Access Compliance Report

Public Rights-of-Way

Intersection ID: 30579	Main Street: CIRCLEGREEN_DR	Cross Street: TRICKLING_WATER_CT	Location: E
ADA ID: BA3CF5396245	Ramp Type: PerpDiag	Initial Pass/Fail: Fail	Overall Compliance: No
		Severity Score: 25

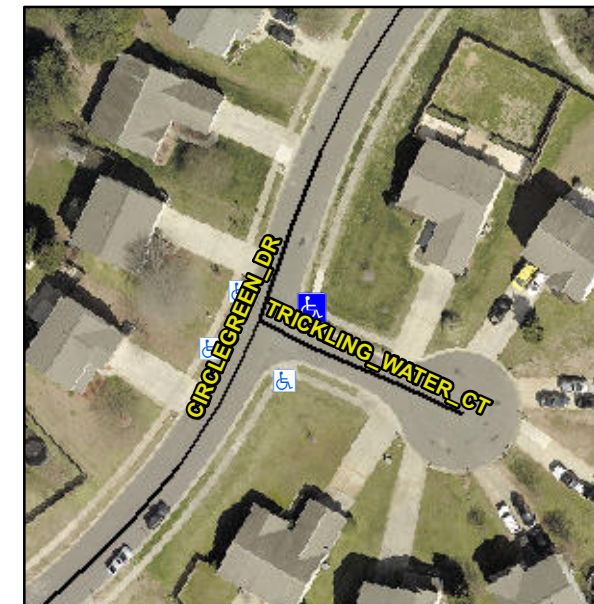
Not Found, R304.5.3

Compliance	Description	Data	Compliance	Description	Data
N/A	Ramp Length (in)	46.0	Yes	Ramp Slope (%)	6.9
Yes	Ramp Width (in)	48.0	No	Ramp XSlope (%)	9.9
N/A	Flare Type LT	N/A	N/A	Flare Type RT	N/A
N/A	Flare Slope LT (%)	N/A	N/A	Flare Slope RT (%)	N/A
N/A	Flare Traversable LT?	N/A	N/A	Flare Traversable RT?	N/A
N/A	Landing Length (in)	N/A	N/A	DWS Provided?	N/A
N/A	Landing Width (in)	N/A	N/A	DWS Contrast?	N/A
N/A	Landing Slope (%)	N/A	N/A	DWS Length (in)	N/A
N/A	Landing X Slope (%)	N/A	N/A	DWS Full Width?	N/A
N/A	Landing Curb? (Y/N)	N/A	N/A	DWS Offset (in)	N/A
N/A	Shared Landing?	N/A			
N/A	Gutter Ponding?	N/A	N/A	Gutter Slope (%)	N/A
N/A	Gutter Lip Ht (in)	N/A	N/A	Gutter X Slope (%)	N/A
N/A	Painted X Walk1?	No	N/A	Painted X Walk2?	No
	X Walk 1 Direction	To NW		X Walk 2 Direction	To SW
N/A	X Walk 1 Width (in)	N/A	N/A	X Walk 2 Width (in)	N/A
	X Walk 1 Slope (%)	5.8		X Walk 2 Slope (%)	1.7
	X Walk 1 X Slope (%)	0.7		X Walk 2 X Slope (%)	5.3

Remove & Replace Curb Ramp With Two New Directional Ramps or Equivalent.
